Subject: SR 429 (Wekiva Parkway)/SR 417 and Interstate 4 Value Engineering Study  
Recommendation Dispositions.

FPID: 240200-4-52-01

## SR 429 (Wekiva Parkway)/SR 417 and I-4 Interchange

### Value Engineering Study **Draft** Report

**RECOMMENDATION No. 25: SR 429 westbound off ramp reconfigure to two lanes**

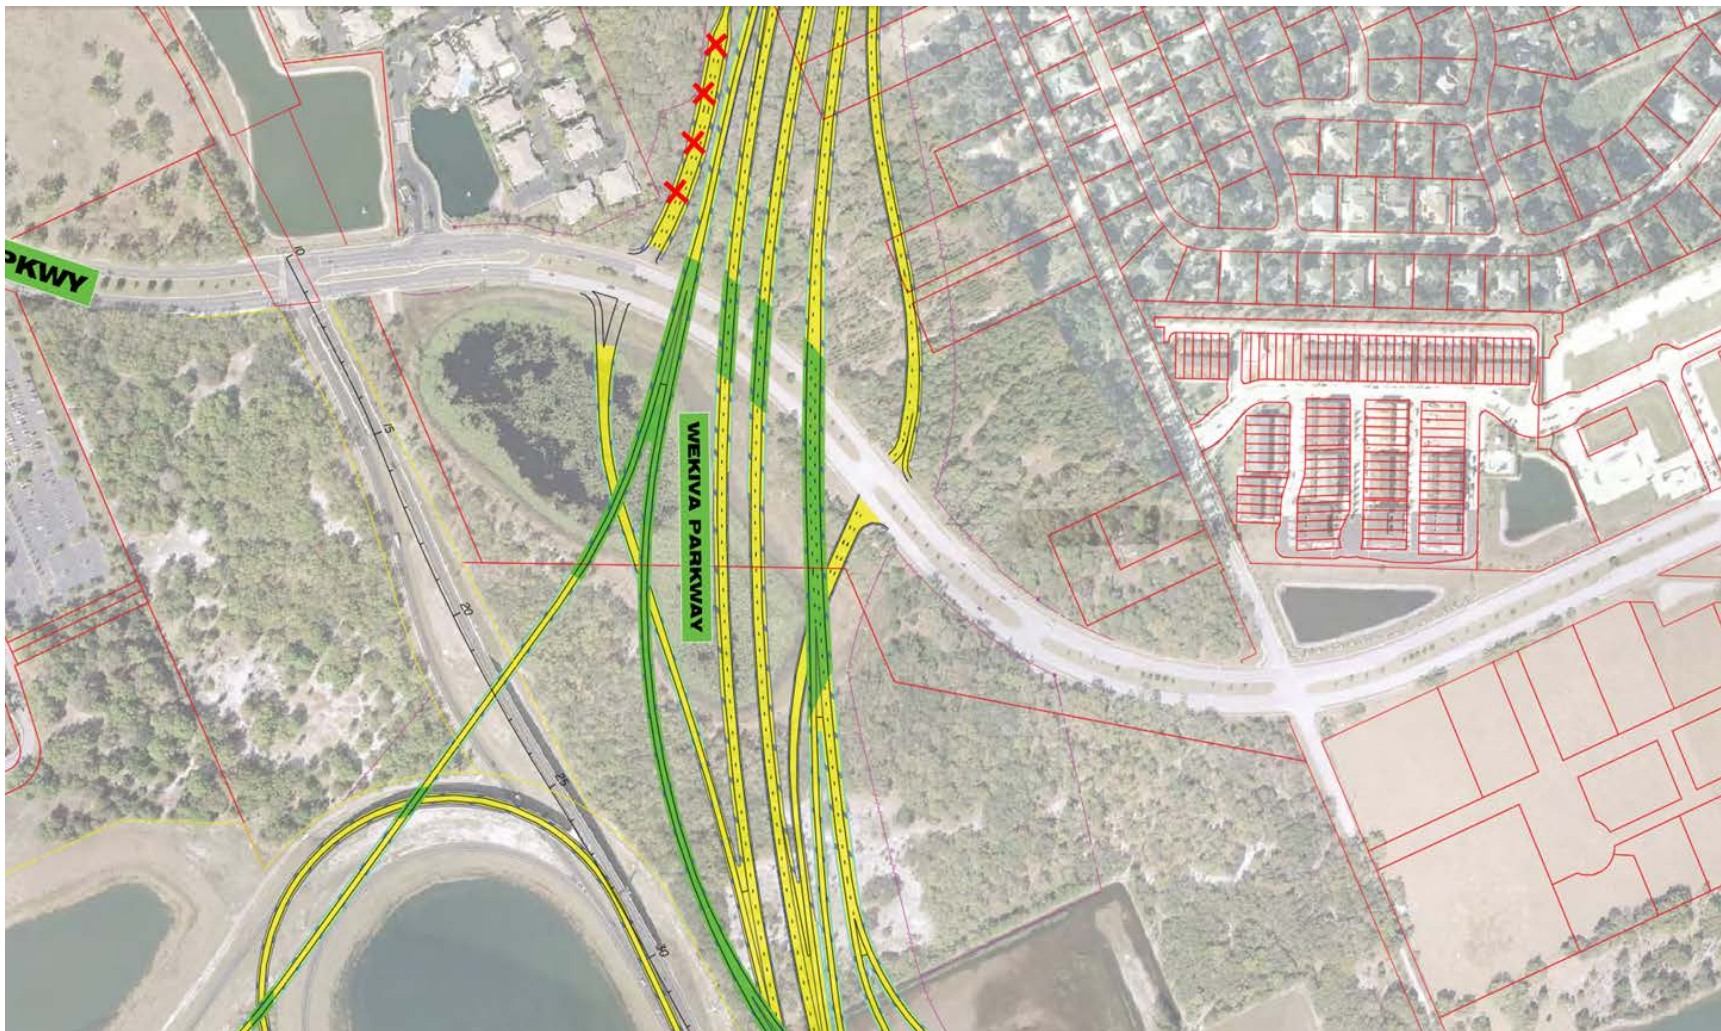
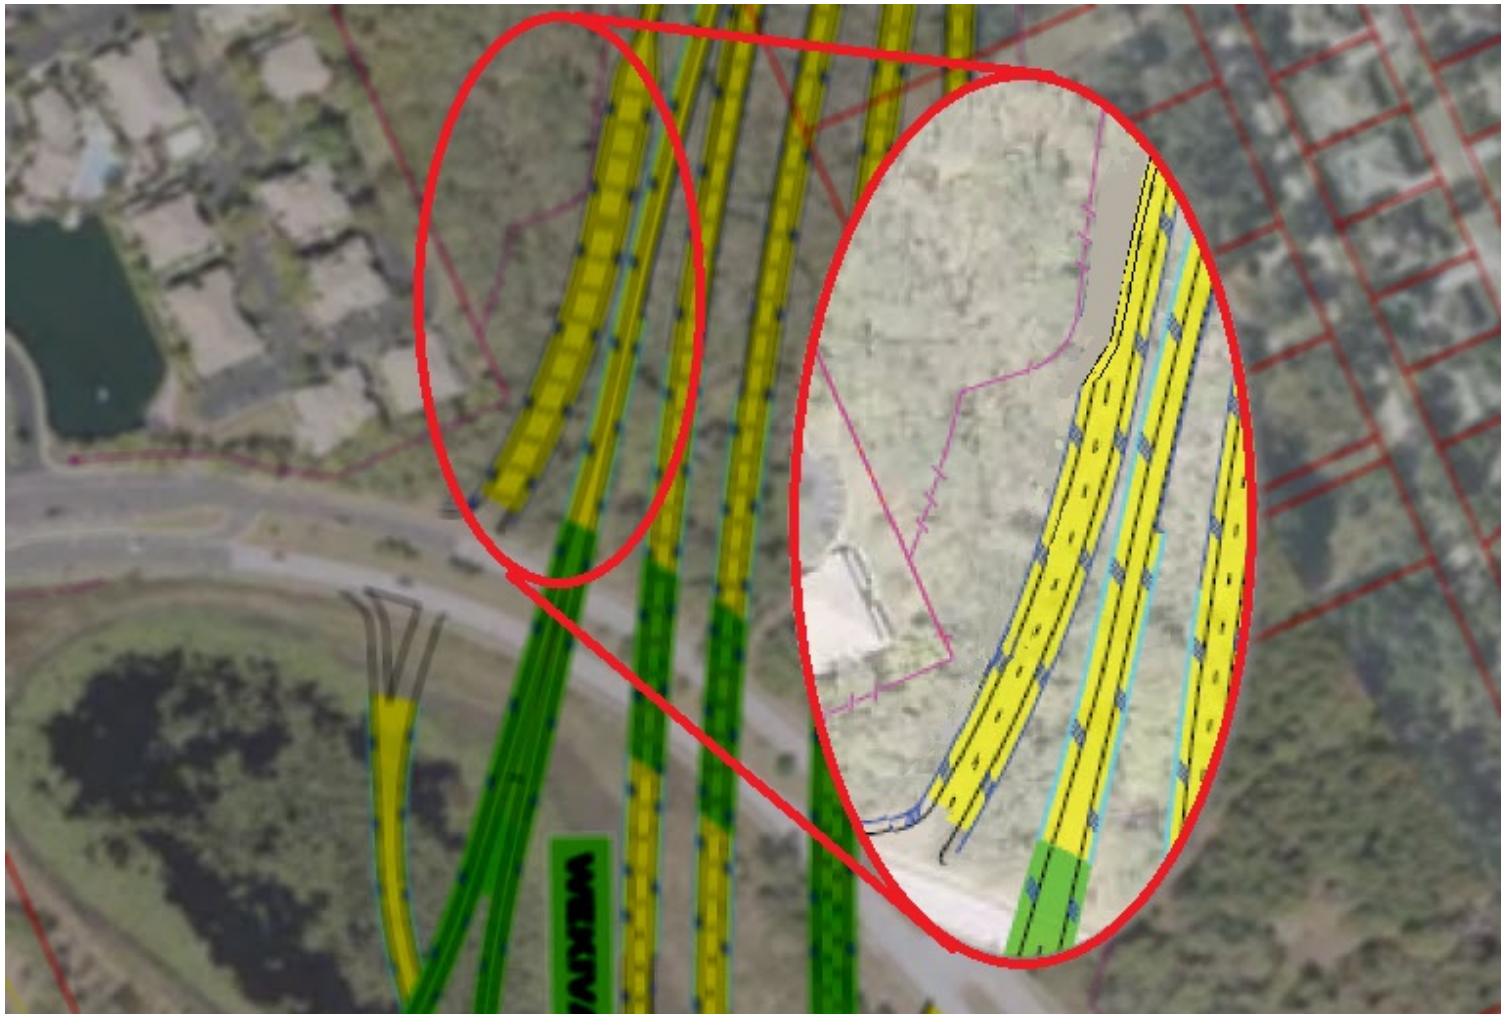
Recommendation 25: SR 429 westbound off ramp reconfigure to two lanes.

Accepted. It appears based upon the revised traffic numbers that this ramp could be reconfigured to two lanes. During the line and grade phase this recommendation will be fully evaluated. (Atkins)

**RECOMMENDATION No. 28: Modify the SR 429 eastbound to I-4 westbound ramps to go under I-4 and the C-D road**

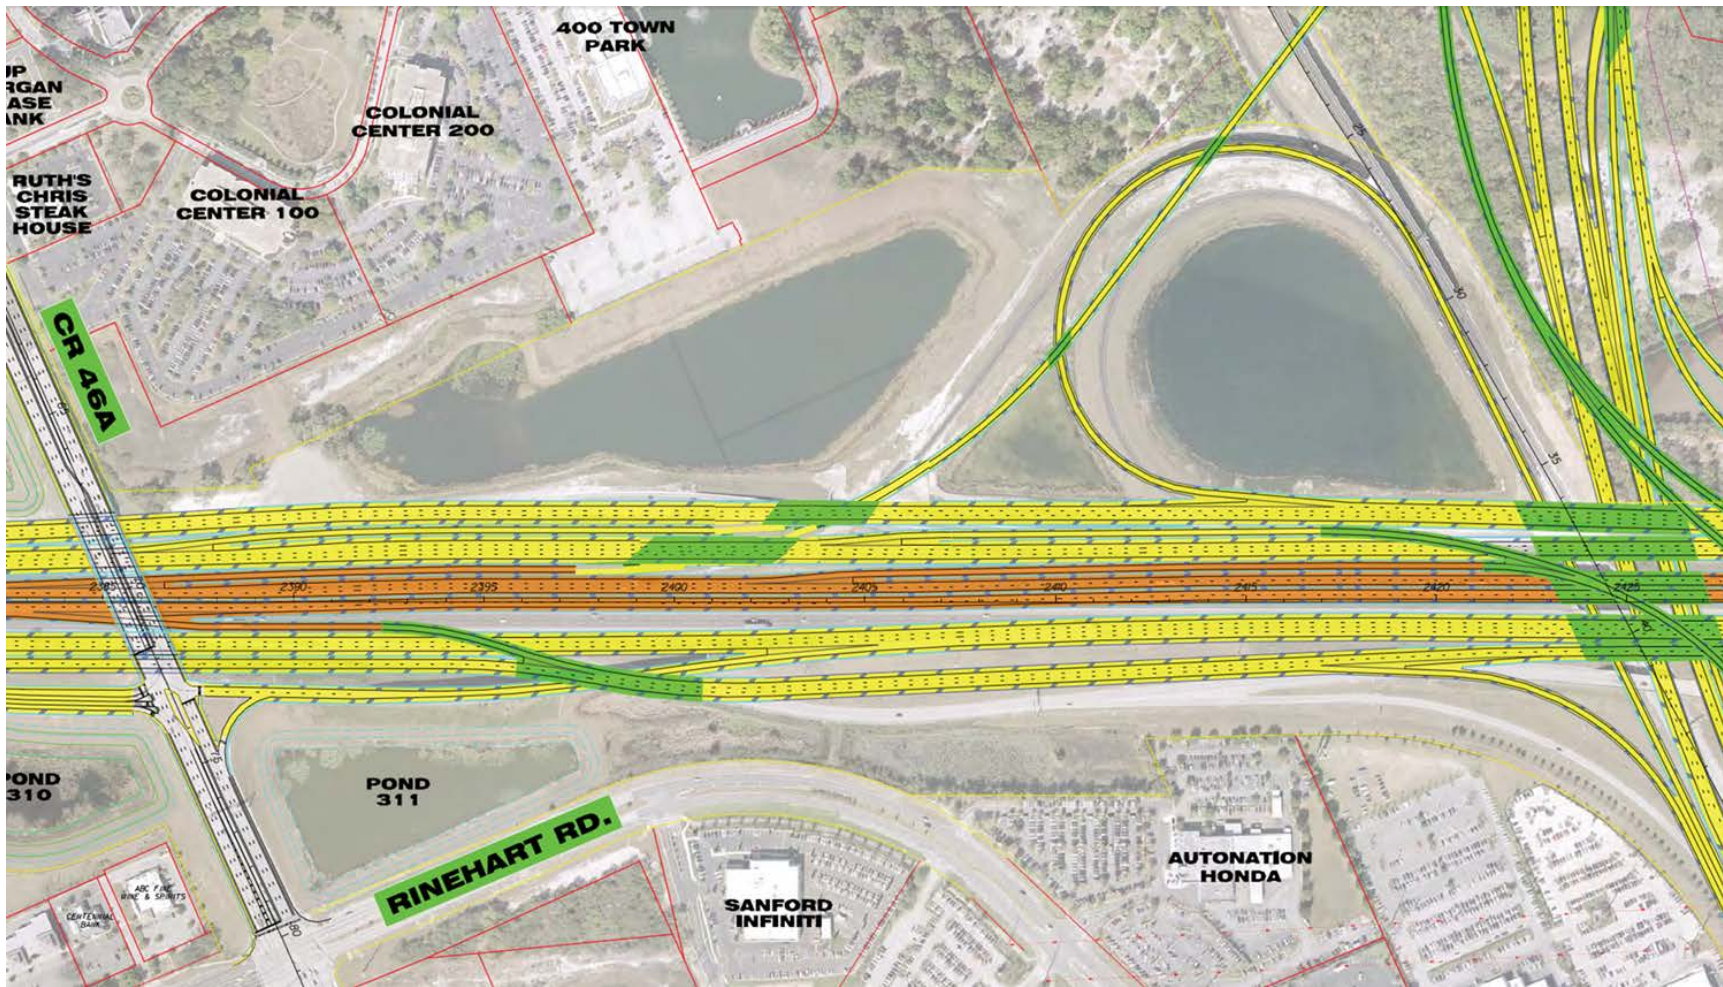
Recommendation 28: As this section of I-4 profile will already be raised to get over SR 417 and SR 429, the VE team suggests that the SR 429 eastbound to I-4 westbound ramps pass under I-4 and connect in a similar manner as proposed by the design team. This concept maintains the SR 429 ramps at grade instead of requiring expensive steel structures while the I-4 bridges could be simple span concrete bridges.

Accepted. It appears that that passing SR 429 eastbound under I-4 westbound is a viable option. Additional analysis during the line and grade phase will be required to determine all the impacts.

**RECOMMENDATION No. 29: Not replacing the bridge and reroute the Cross Seminole Trail up to CR 46A and incorporate the Trail in to a nice pedestrian crossing at that location**

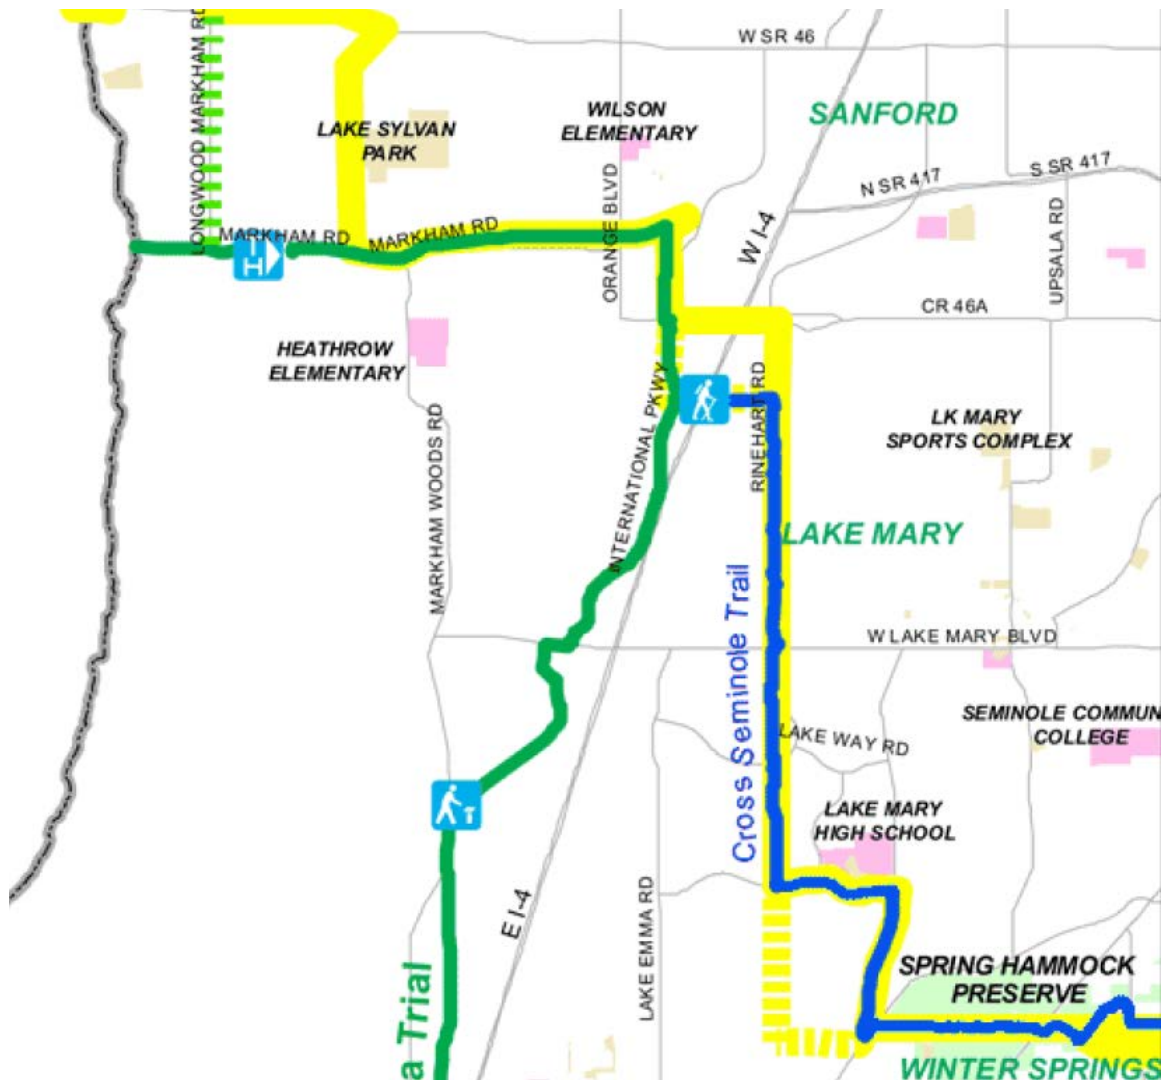
Recommendation 29: The VE Alternative consists of rerouting the Cross Seminole Trail to the I-4/CR 46A Interchange. This would include providing enhanced pedestrian improvements on the Ultimate CR 46A Interchange Bridge configuration to accommodate a multi-use trail in addition to the standard pedestrian pathway. The Florida National Scenic Trail currently certifies the existing CR 46A crossing at I-4 as a northern extension of the Cross Seminole Trail at the intersection of International Parkway and CR 46A.

Rejected. The concept has been modified to not impact the pedestrian bridge crossing I-4 so rerouting the Cross Seminole Trail will not be necessary.

**RECOMMENDATION No. 31: Eliminate the C-D road in the southeast corner of the interchange**

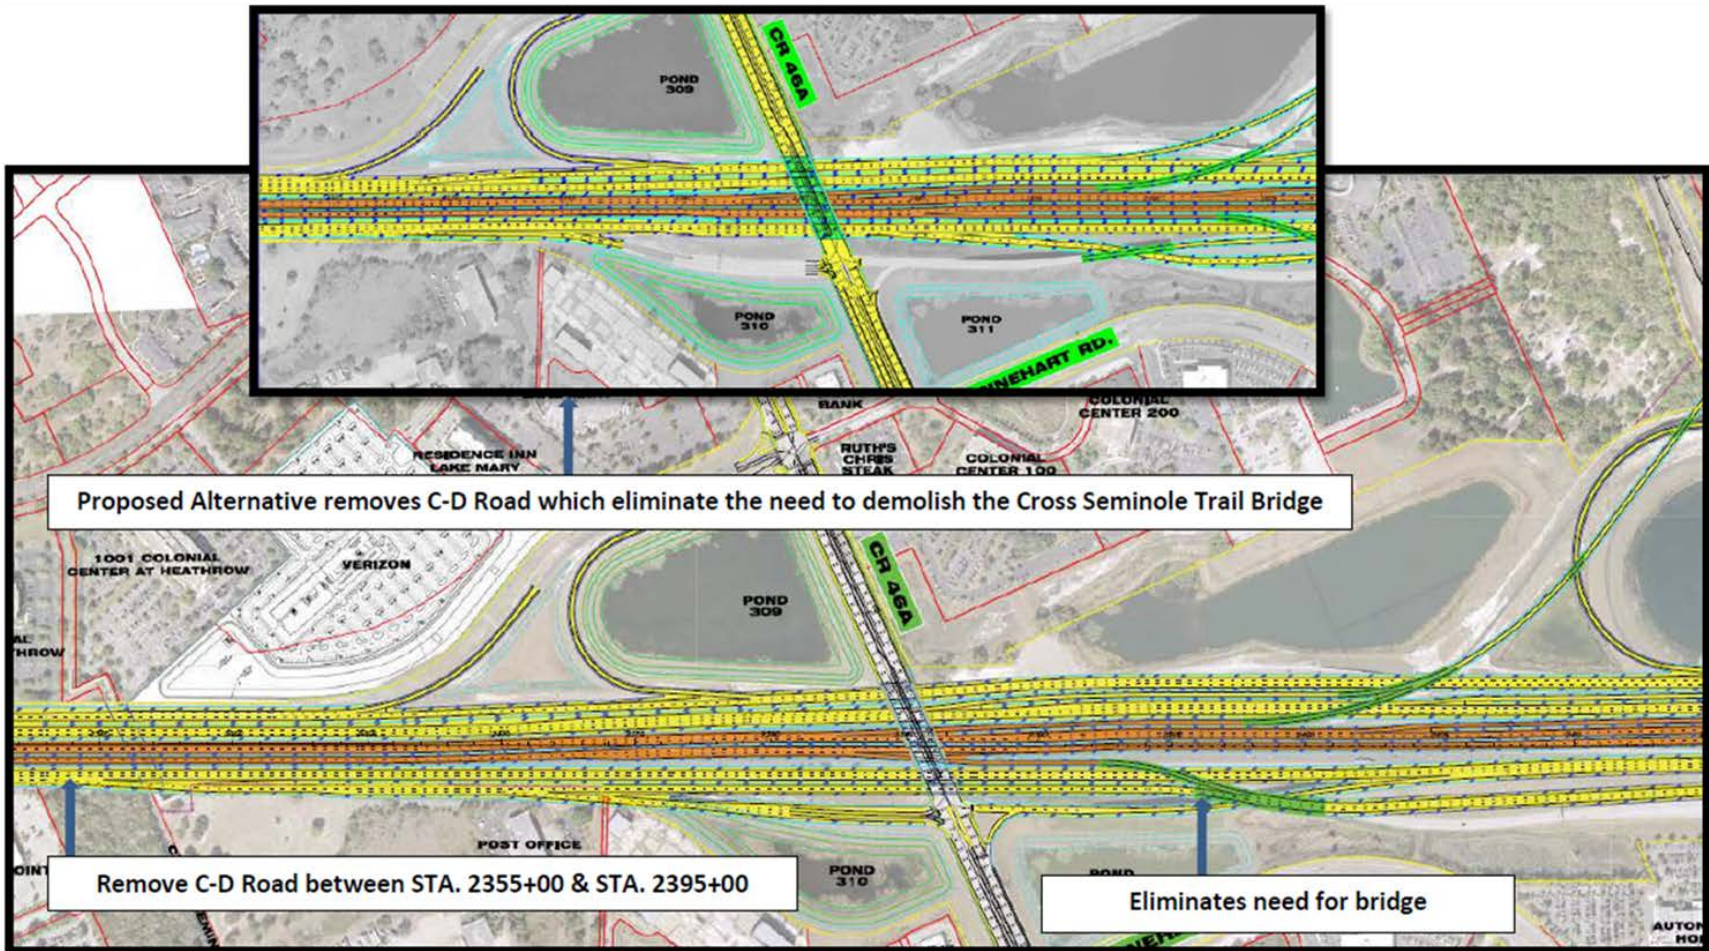
Recommendation 31: Shift the entrance of the C-D road from Sta. 2355+00 to 2389+00. The C-D road is then brought under the CR 46A on ramp as existing before continuing onto the SR 417/SR 429 Interchange. This proposal will be a cost savings in both not demolishing the Cross Seminole Trail and in roadway and bridge construction.

Accepted. The entrance of the C-D road will be shifted east so that it does not impact the Cross Seminole Trail pedestrian bridge.
